# PD 1509

Re: Minor Change to PD 1509  
Sub-parcel 1.H

**Re: MODIFIED Request for Minor Change to Business-Residential Planned  
Development No. 1509  
Bronzeville Lakefront (Sub-Parcel 1.H Interim Site Plan)**

## Landscape Ordinance Comparison Bronzeville Lakefront - Temporary Parking Lot

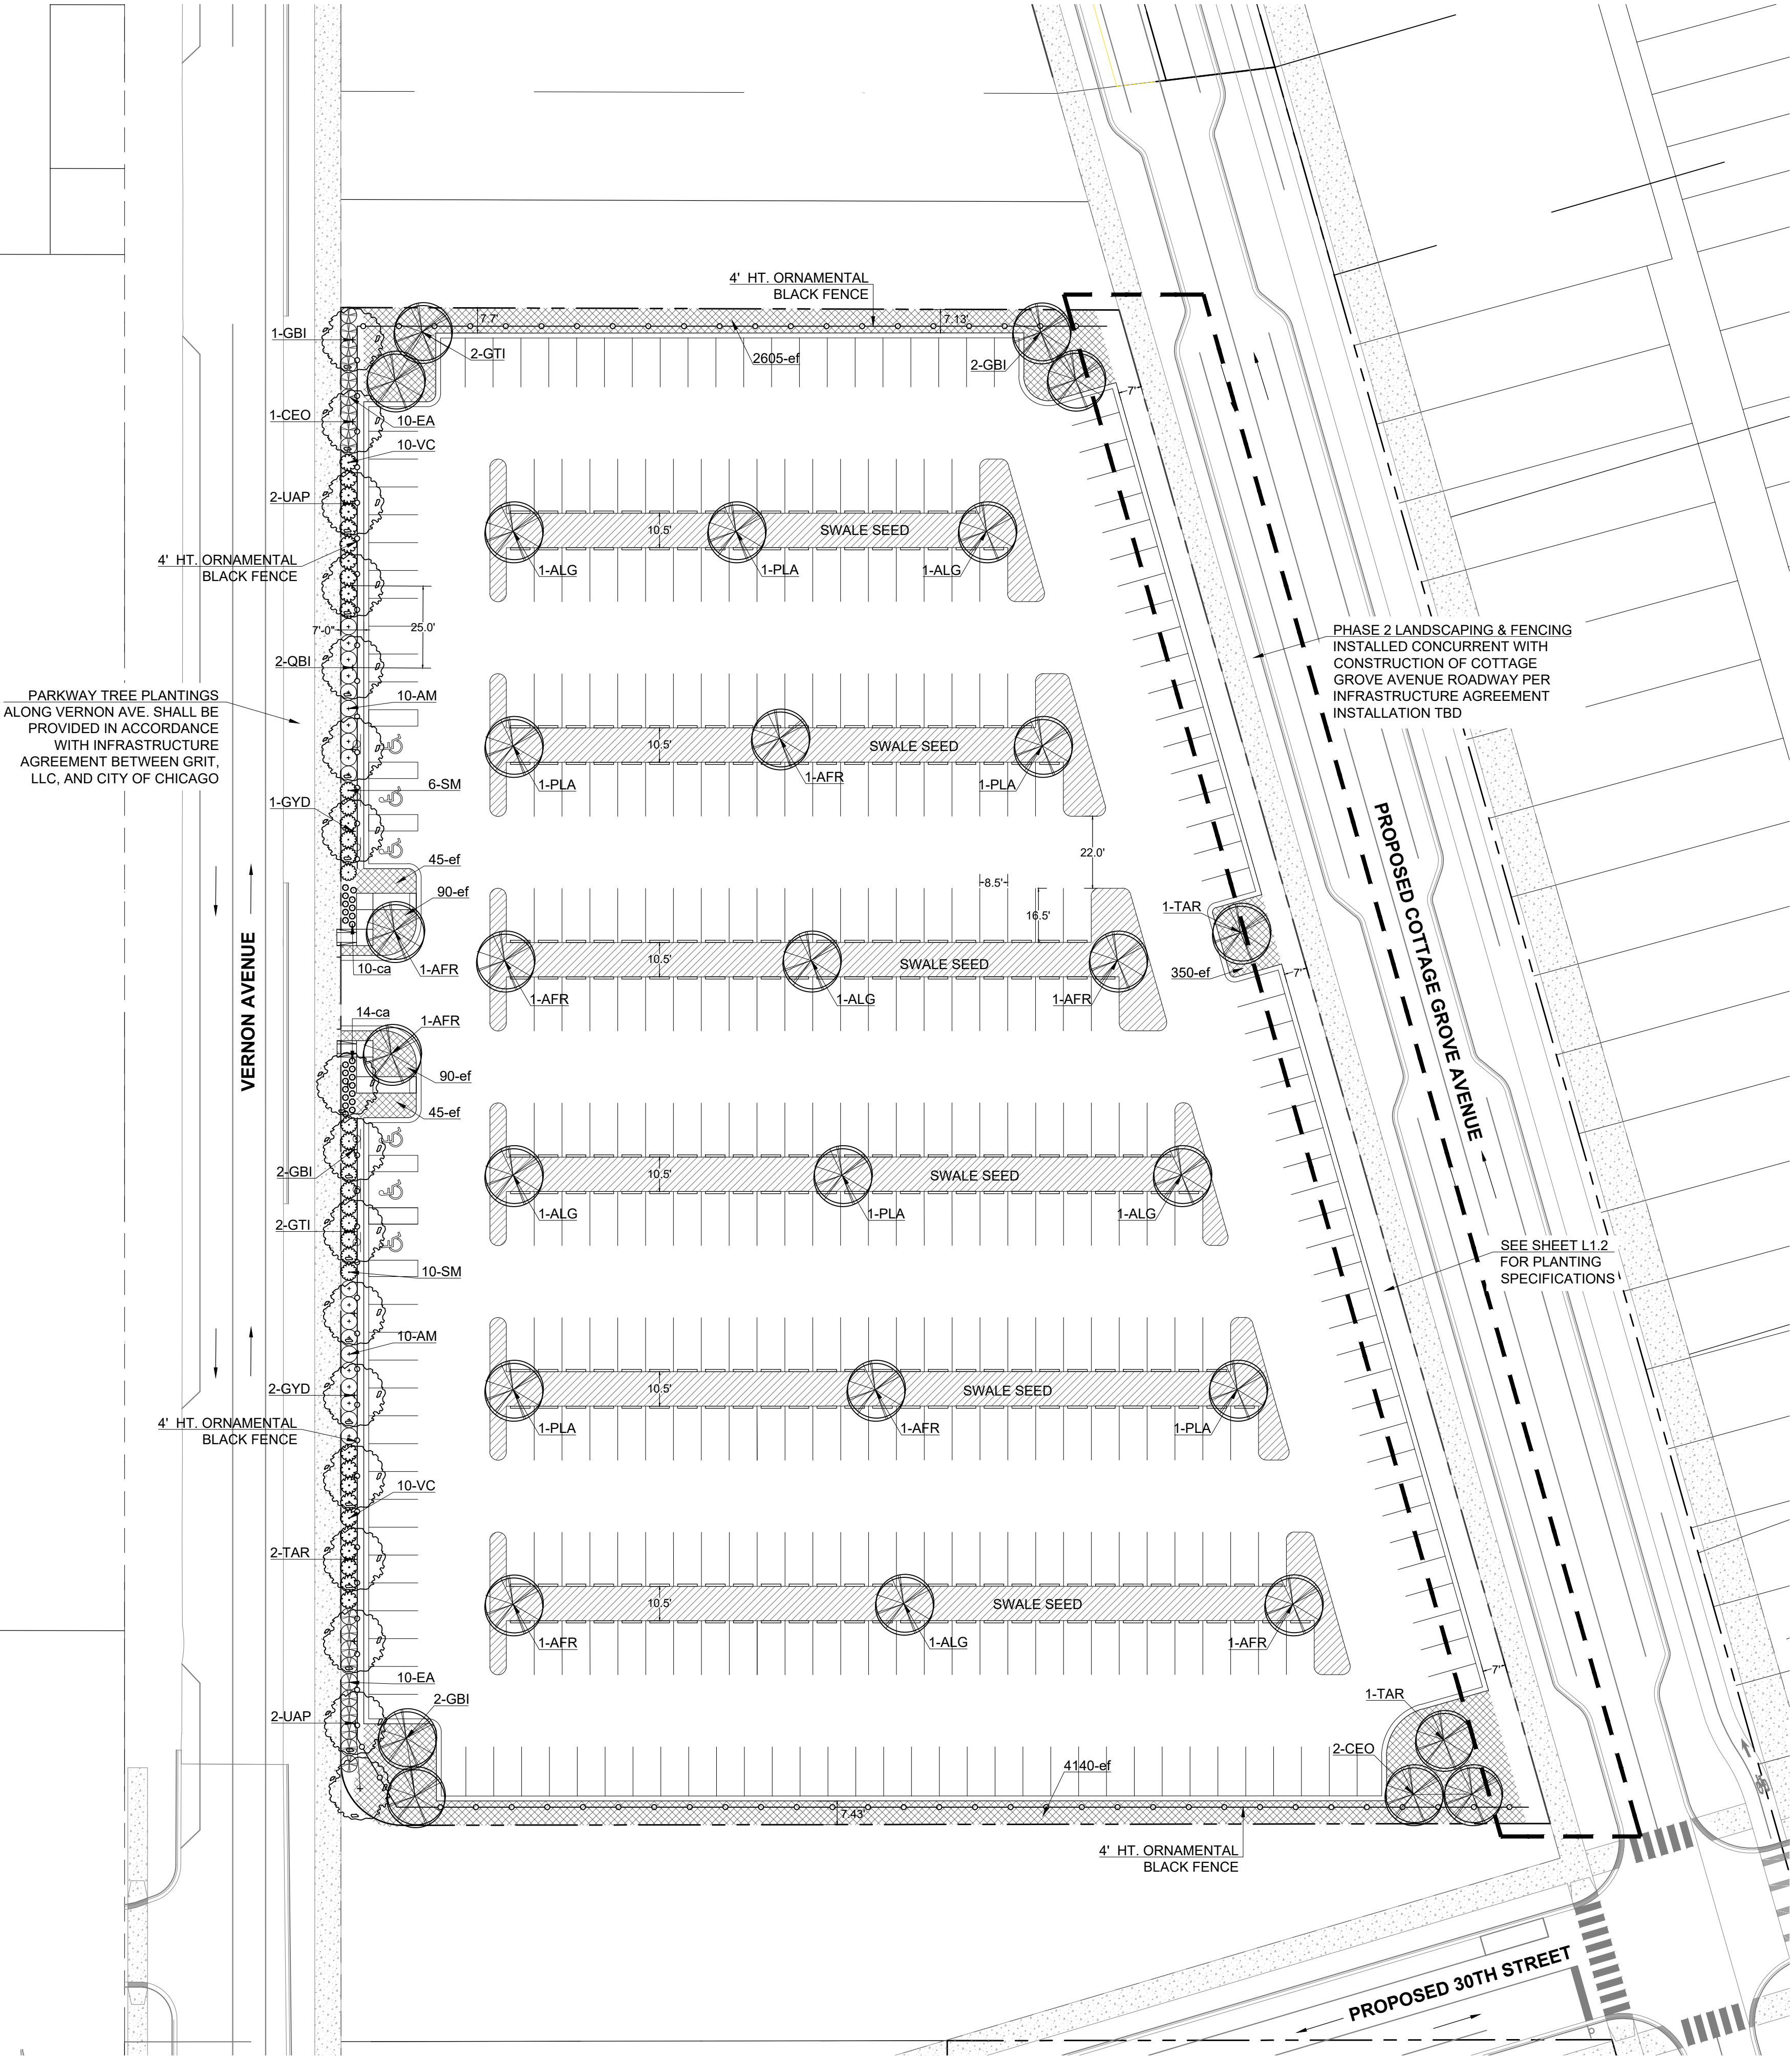
- Eliminate the hose bibb requirement for the perimeter landscape area and provide a long-term watering and maintenance contract in lieu of the hose bibs.
- Install only 30 of the 88 required interior trees on the subject site, as shown on the attached Landscape Plan Phase 1 and Landscape Plan Phase 2.
- Install the remaining 58 required interior trees throughout Subarea 3A, as shown on the attached Site A, Site B, Site C, Site D, and Site E Site Plans.
- Provide planted ground cover and native seed mix in the internal landscape islands.

1. Calculation based on Cottage Grove Ave. and Vernon Ave. ROW frontage only.
2. In lieu of hose bibs a watering contract shall be provided to confirm watering is provided.
3. An additional 58 trees shall be provided within the PD Boundaries.
4. Living Ground Cover will consist of planted ground cover and native seed mix in internal depressed islands.

Regarding your request, the Department of Planning and Development has determined that allowing the proposed modifications will not create an adverse impact on the Planned Development or surrounding neighborhood, will not result in an increase in the bulk or density, and will not change the character of the development, and therefore, would constitute a minor change. The duration of the interim parking lot condition is approved for a period thirty-six months with the ability to request a 1-year extension, via a minor change. Accordingly, pursuant to the authority granted by the Chicago Zoning Ordinance and PD 1509, I hereby approve the foregoing minor change, but no other changes to this Planned Development.

PRELIMINARY LANDSCAPE PLAN  
PHASE 1  
PLANTING REQUIREMENTS  
FENCE DETAIL

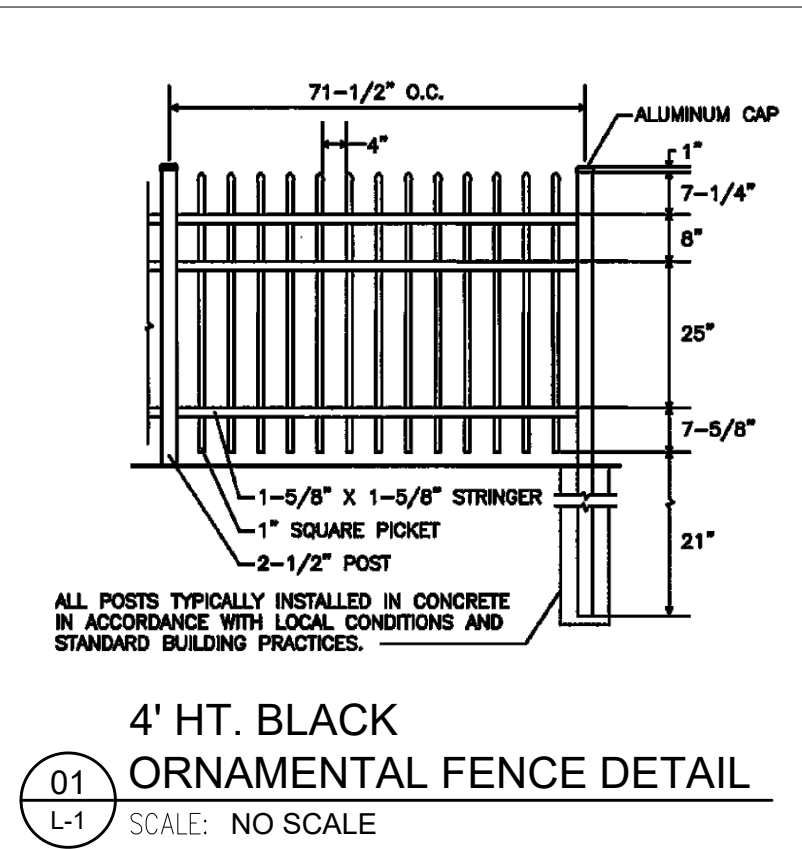
- Preliminary Landscape Plan Phase I Planting Requirements Fencing Detail, Sheet L 1.1, prepared by Kathryn Talty Landscape Architecture as Job No. 21460 and dated “per City Comments” as of January 7, 2022;
- Preliminary Landscape Plan Phase II Construction Notes Planting Details, Sheet L 1.2, prepared by Kathryn Talty Landscape Architecture as Job No. 21460 and dated “per City Comments” as of January 7, 2022; and
- Plan depicting location and planting details of 58 additional trees to be located elsewhere within the PD.

While the initial minor change plan omitted perimeter trees, perimeter trees are now provided along the length of Cottage Grove Avenue and Vernon Avenue. Thirty-eight perimeter trees are required. Thirty-eight perimeter trees are provided.

- The modifications also restore ornamental fencing to the plan, in excess of what was contemplated by the PD-approved plan. The PD-approved plan specified a 4-foot tall ornamental metal fence in the areas adjacent to Vernon Avenue and Cottage Grove Avenue. No fencing was specified along the northern or southern boundaries, or along the interior eastern boundary. The initial minor change plan sought to substitute the ornamental fencing with chain link fencing due to the construction activities that would immediately ensue on the adjacent rights of way. However, in response to DPD's comments, the enclosed modified plans depict 4-foot tall ornamental fencing on all sides of the interim parking lot.

- Interior trees have been restored to the enclosed modified plans. The initial minor change plans omitted interior trees. The interior landscaped islands are acting as swale areas and will be planted with living material consisting of planted ground cover and native seed. Because trees are not as able to withstand the swale function, the Applicant proposes to reduce the number of trees in the internal islands. Due to the temporary nature of the interim lot, the tree canopy would not have sufficient time to mature to impact the heat island effect. Instead, to offset the required number of internal trees, the Applicant would install trees elsewhere within the PD, as shown on the enclosed plans. Eighty-eight internal trees are required. Thirty internal trees would be located in the interim lot, and the remaining 58 would be located in the PD, as shown on the enclosed plans.

- To optimize construction sequencing, plantings and fencing in the landscaped buffers will be installed in two phases, as depicted on the enclosed plans. Plantings and fencing along the northern, southern, and western (Vernon Avenue) perimeters and on the interior of the interim lot will be installed in the first phase. Plantings and fencing along Cottage

**Sub-Parcel 1.H Interim Site Plan**  
**Exhibit 17**

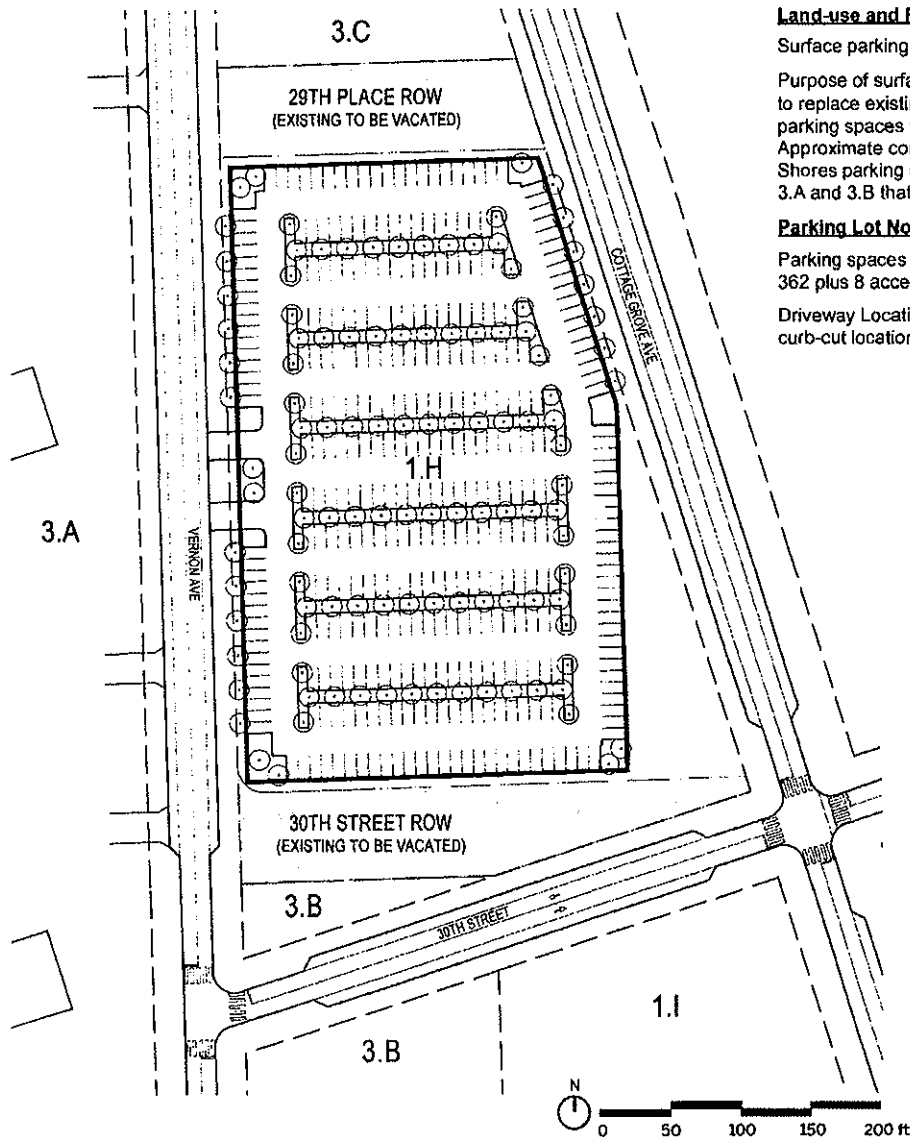
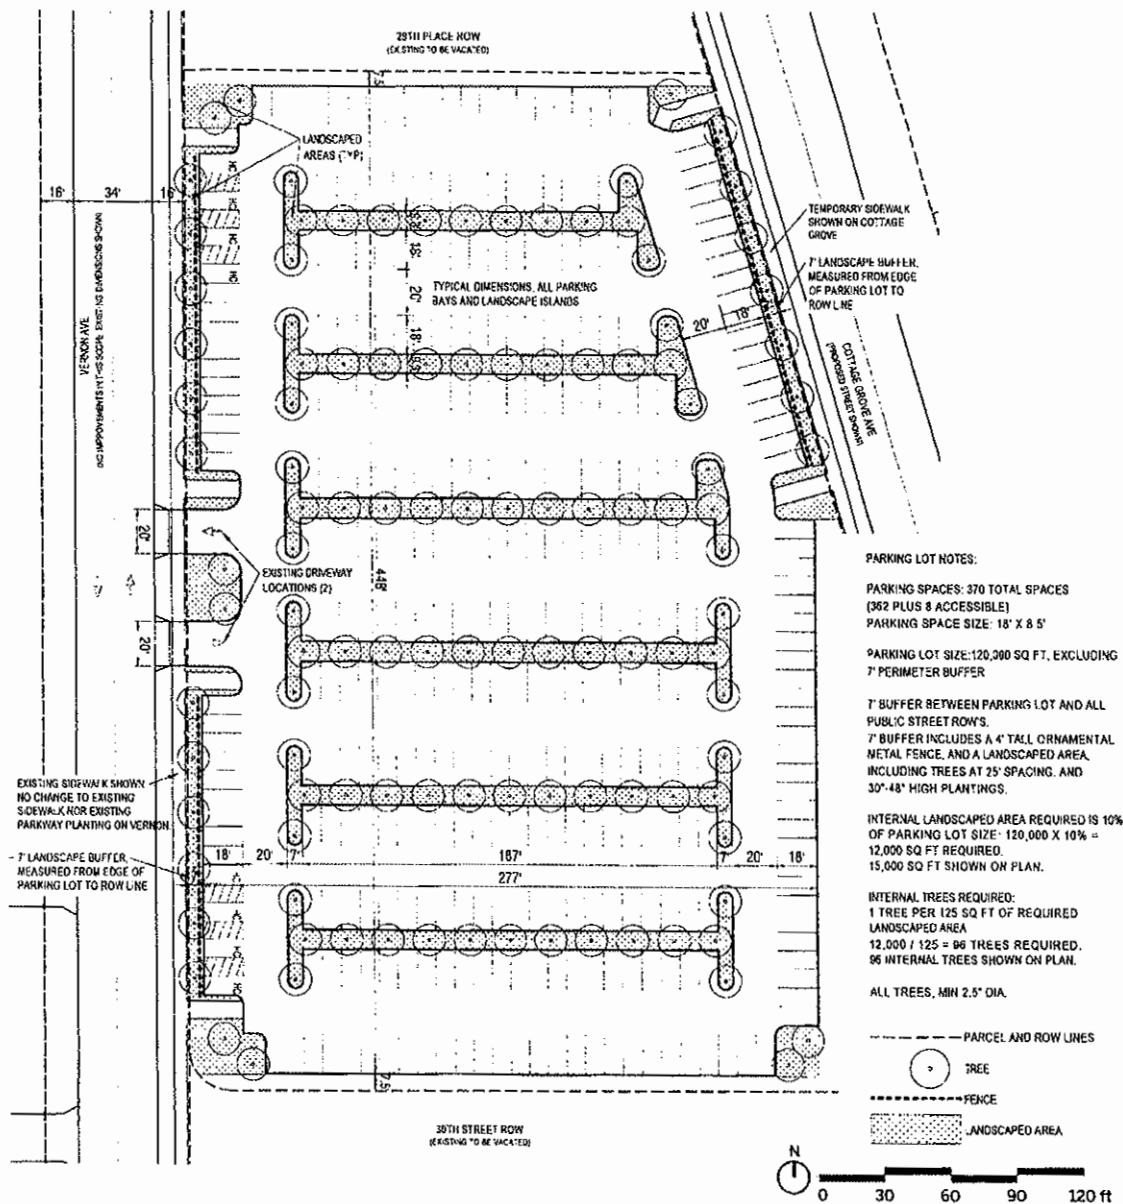
- The modifications include reconfiguring the interim parking lot so that its eastern boundary follows the line of Cottage Grove Avenue. On the PD-approved plan, the eastern boundary was adjacent to Cottage Grove only at the northeast corner of the interim lot.

- The enclosed modified plans also provide more internal landscaped area than was specified on the PD-approved plan. The PD-approved plan specified 15,000 square feet of internal landscaped area, which was 25% more than what the Landscape Ordinance requires. Based on the adjusted interim lot configuration and area, the initial minor change plans proposed 16,160 square feet of internal landscaped area, which was approximately 46% more than what the Landscape Ordinance requires. The enclosed modified plans depict 29,565 square feet of internal landscaped area, which is 173% more than required by the Landscape Ordinance.
